Addendum # 7

PROJECT NAME: SUU Old Main Building Renovation
Southern Utah University
Cedar City, Utah

DATE: September 21, 2004

DFCM Project No.: 003234730
CRSA Project No.: B04-012

B1a
SP204

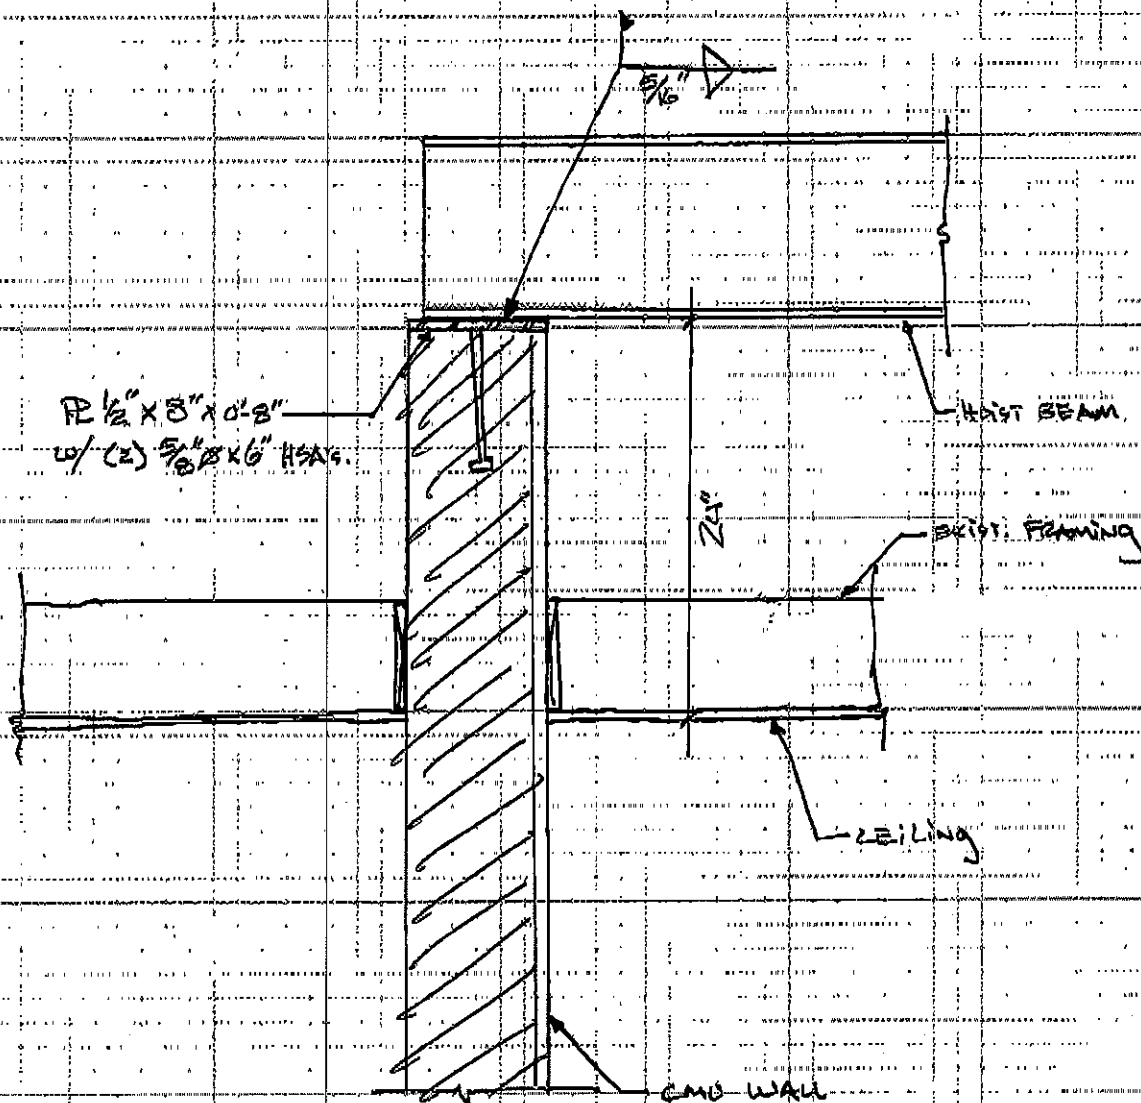
- a) Add detail B1a. See attached drawing.
- VI-7 AE402A, AE403A, & AE404A – Interior Elevations
 - a) The plinth Blocks are to be installed at the door frames and are to be 2645CP by Huetter Mill or similar.

ELEVATOR HOIST BEAM

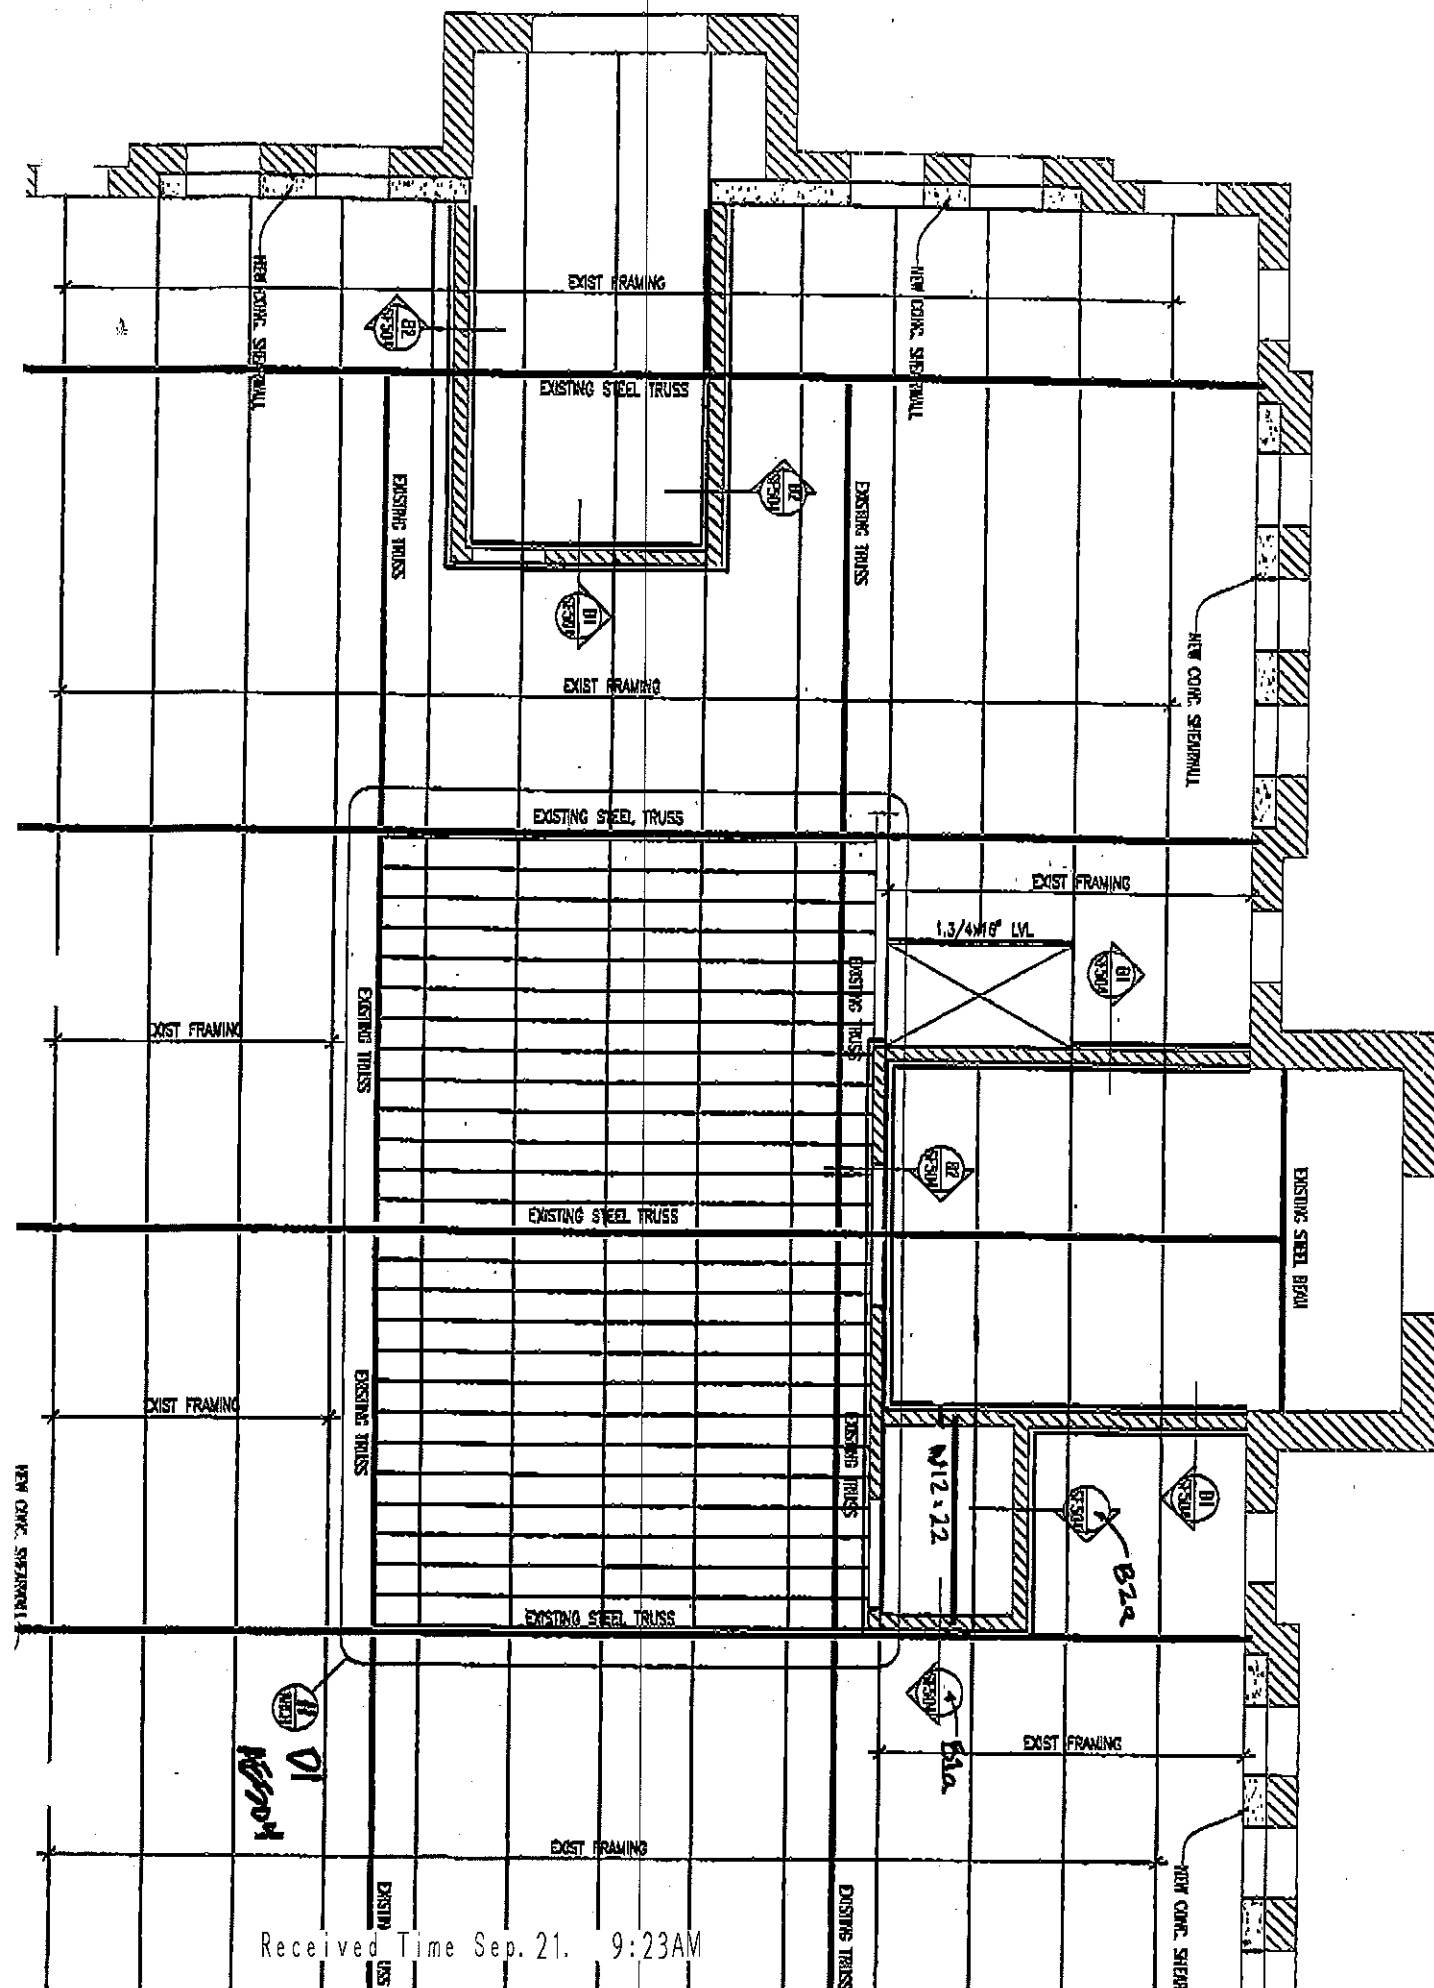
- VI-5 SF104 – Third Floor Ceiling/Truss Bottom Chord Framing Plan
 - a) Add the elevator hoist beam as shown on the attached drawing.
- VI-6 SF504 – Framing Details
